A.P.4347J, Vol. 2
Leaflet No. T.1

Hunter F.G.A. Mk. 9 Aircraft - Centre Fuselage, Cabin Conditioning Feed Pipe, Expansion Joint Revised

A.P. 4347J, Vol.2
Leaflet No. T.2

Hunter FGA. Mk.9 Aircraft - Cabin conditioning System - Ductstat Guard Introduced

Drawing No. A.P.4347J/T.2/62

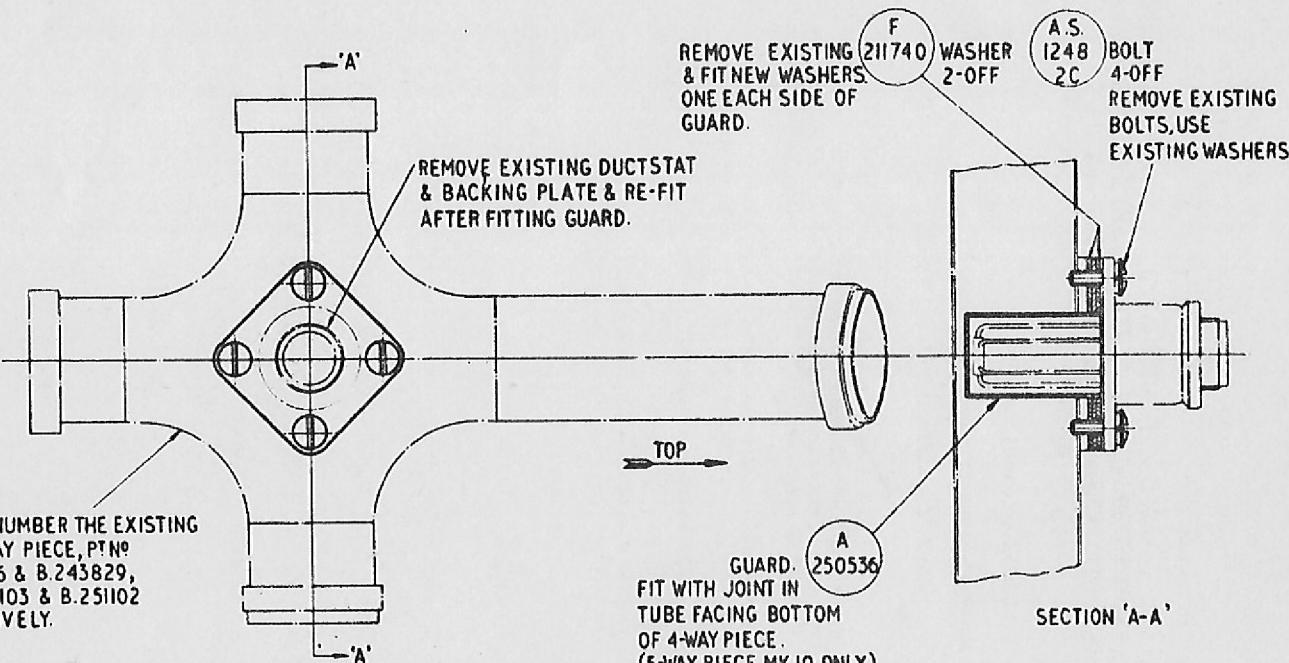
A guard is introduced to prevent ice fracturing the ductstat element.

- (4) Insert guard, Part No. A.250536; sandwiching between two new washers, Part No. F.211740, as shown on the drawing.
- (5) Re-assemble ductstat, Part No. F.H.G./A/49 complete with existing spring washers, Part No. SP.47.C (4 off) and backing plate, Part No. F.211739 using new bolts as shown on the drawing.

RE-PART NUMBER THE EXISTING
4 OR 5 WAY PIECE, PTN#
C.205316 & B.243829,
AS C.251103 & B.251102
RESPECTIVELY.

DRG. No. A.P. 4347J/T4/63
SHEET 1

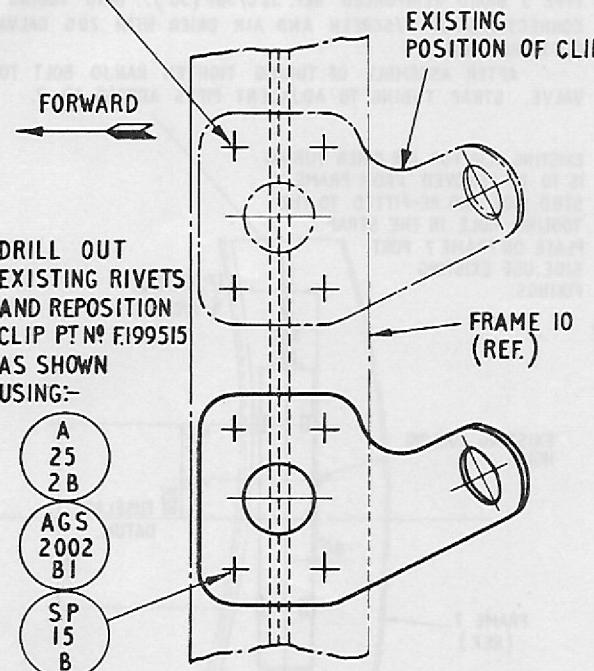
- (15) At frame 10, starboard side, drill out rivets and remove existing clip, Part No. F.199515, re-fit, in position shown and fill redundant holes as shown on the drawing.
- (16) Temporarily remove bottle from sub-assy. of bottle, Part No. B.251063. Locating from existing tooling hole, mark off and drill 1 hole Morse No. 10 in frame. Drill out rivet and open up hole to Morse No. 10. Bolt bracket to frame. Mark off 1 hole in bracket and drill 1 hole Morse No. 10 through bracket and frame and fit bolt and distance tube. Re-fit bottle ensuring that it is tightly screwed up to cap as shown in detail 'B' of drawing No. D.250327.
- (17) Remove crowbar (Ref. No. 1A/3948) from attachments at frames 11 and 12 (if fitted).

REDUNDANT HOLES TO
BE FILLED WITH:-

A 25 1B AGS 2002 BI SP 15 B

FORWARD
DRILL OUT
EXISTING RIVETS
AND REPOSITION
CLIP PT N° F199515
AS SHOWN
USING:-

A 25 2B
AGS 2002 BI
SP 15 B

CLIP FOR PILOT'S HARNESS
FR.10 REPOSITIONED.

DRG. No. A.P. 4347J/T4/53
SHEET 2

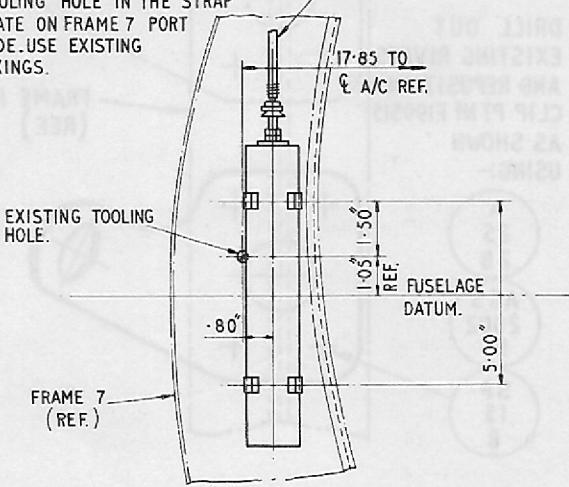
- (8) Remove the gun pack (A.P. 4347, Vol. 1, Sect. 7, Chap. 3, refers).
- (9) Remove air drier, Part No. A.5500 (Triplex) from forward face, starboard side, frame 8. Detach from windscreen banjo as shown on the drawing.

- (10) Locate and drill 2 holes Morse No. 25 at aft face, port side, of frame 7 as shown on the drawing.
- (11) Remove vacated spring clips, Part No. AS.2294/9 (2 off) from frame 8, open holes to Morse No. 25 and bolt to frame 7 as shown on the drawing.

- (12) Remove tube from air drier and fit new tube 3/16 in. dia. x 9/16 in. o/dia. x 36 in. long, type 3, braid reinforced (ref. No. 32C/509) to air drier. Clip air drier into position at frame 7 and join up to banjo on windscreen as shown on the drawing (see also instructions at detail 'F' on Drawing No. C.232141).

CLOSE THE DEHYDRATOR VALVE ON W/SCREEN BY SLACKENING BANJO BOLT. REMOVE EXISTING TUBING FROM BANJO CONNECTION AND AIR DRIER. (CARE TO BE TAKEN TO PREVENT INGRESS OF MOISTURE INTO AIR DRIER.)

FIT TUBING $\frac{3}{16}$ " I/D X $\frac{9}{16}$ " O/D X 36.0" LONG D.T.D. 625 A
TYPE 3 BRAID REINFORCED REF. 32C/509 (36"). BIND TUBING AT
CONNECTIONS OF W/SCREEN AND AIR DRIER WITH 20G. GALVANISED
SOFT IRON WIRE.

AFTER ASSEMBLY OF TUBING TIGHTEN BANJO BOLT TO OPEN VALVE. STRAP TUBING TO ADJACENT PIPES ACROSS FR. 7.

EXISTING CLIP FOR AIR DRIER TUBING
IS TO BE REMOVED FROM FRAME 7
STBD. SIDE AND RE-FITTED TO THE
TOOLING HOLE IN THE STRAP
PLATE ON FRAME 7 PORT
SIDE. USE EXISTING
FIXINGS

REMOVE AIR DIER FROM FORWARD FACE OF FR. 8 ST.B'D. SIDE.
REPOSITION AS SHOWN ON PORT SIDE - FR.7-FT. FACE USING
EXISTING SPRING CLIPS AS. 2294/9 (2-OFF) ATTACH CLIPS TO
FRAME WITH: - A 25 AGS SP DRILL FRAME 7

OPEN UP HOLES IN CLIPS TO MORSE N° 25.

VIEW LOOKING FWD. ON AFT FACE OF FR.7 PORT SIDE.
SHOWING REPOSITIONING OF AIR DRIER CONTAINER.
